7 February 2002

Subject: Comments on Recently Received Documents Pertaining to
Seattle Tacoma International Airport Project
Third Runway – Low Flow Analysis

Figure 6: Comparison of 1-Dimensional versus 2-Dimensional Flow in Uniform Fill Columns (25 ft thick) with Port Properties

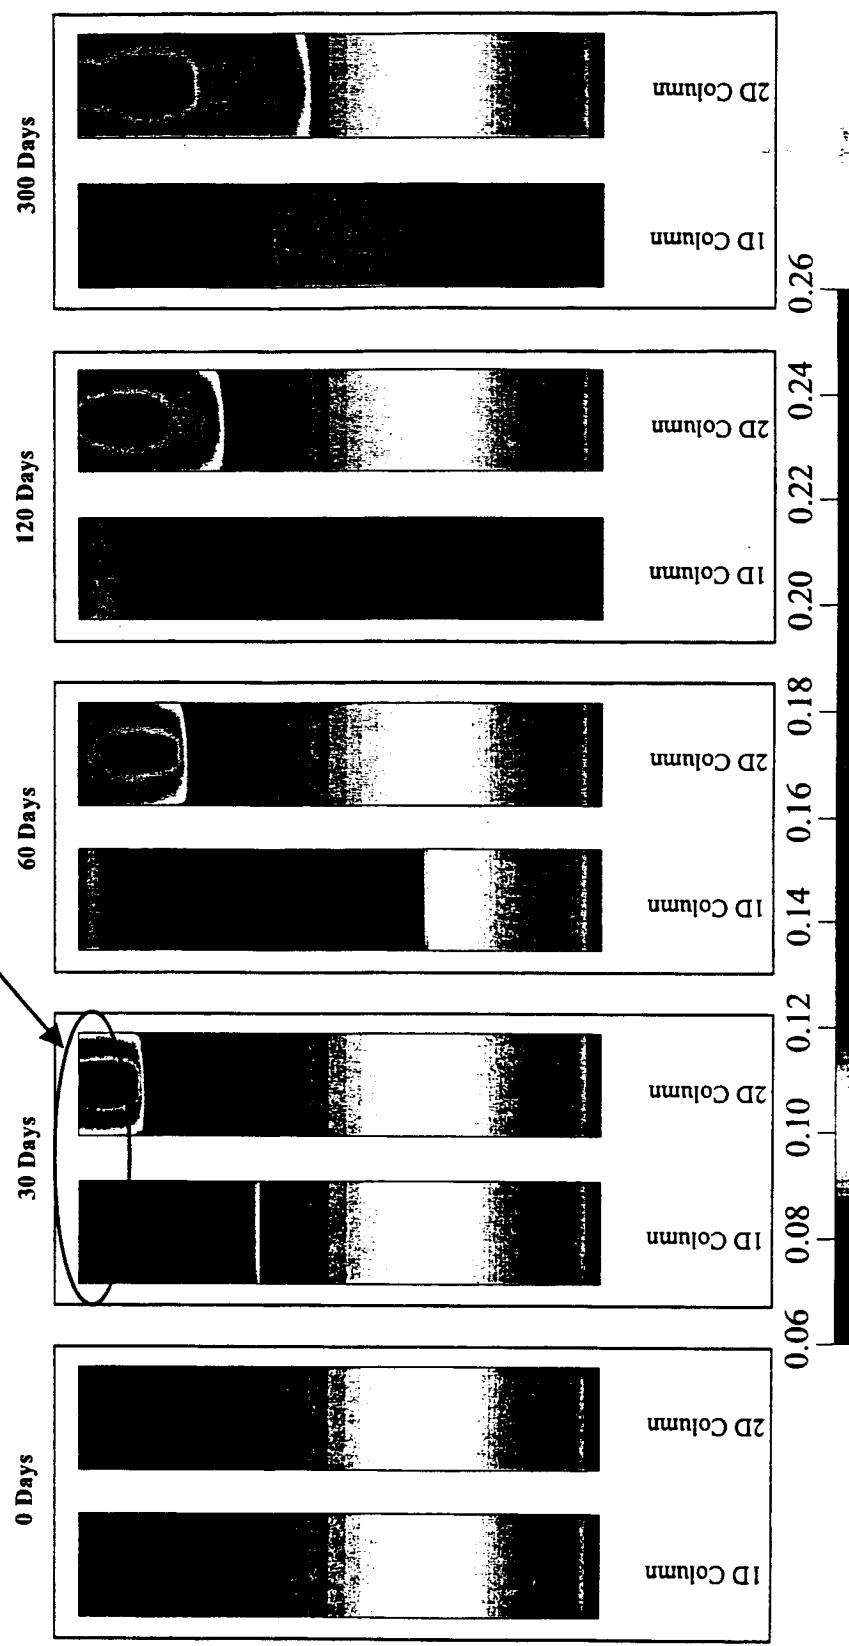
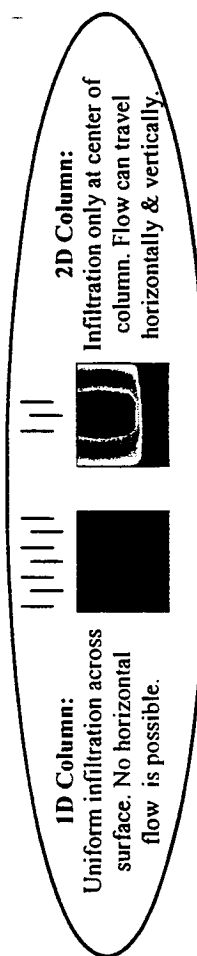
To demonstrate the impact of horizontal flow on the travel time of water flowing through the embankment, two sets of analyses were performed using the Port's soil properties as shown on Figure 6. Two 25 ft thick fill columns were modeled in Hydrus. In the 1-Dimensional (1D) column, water infiltrating at the top of the column travels downward vertically, without an opportunity for any horizontal flow (same analysis as described in Comment 2). In the 2-Dimensional (2D) column, water was applied over the middle 2/5th of the column only, but once the water entered the soil column, it was allowed to travel both vertically and horizontally. This 2-Dimensional scenario is representative of precipitation adjacent to the runway or filter strips (as seen on Figure 5), where water landing directly on the fill surface can pass directly into the embankment, but water landing on the impermeable runway or filter strips cannot.

Comparison of the 1D and 2D columns on Figure 6 makes the impact of horizontal flow immediately apparent. After 30 days, while flow in the 1D column has had nowhere to go but downwards (represented by the advancing dark colored wetting front), flow in the 2D column has traveled downwards and laterally (represented by the dark colored center and lighter colored bands spreading outwards both in front and on the sides of the wetting front). By 60 days, the wetting front in the 1D column has traveled approximately two thirds of the distance to the drain, while the 2D column wetting front has only progressed a quarter of the distance to the drain. This trend continues throughout the analysis, as the 1D column can only send water downwards, while the 2D column continues to allow water to fill in underneath the impermeable regions on either side of the entry point. Clearly, without incorporating this effect into their analysis, the Port is overpredicting the rate at which water flows through the fill, and therefore their estimates of the time at which flows will arrive at the creek will not be representative.
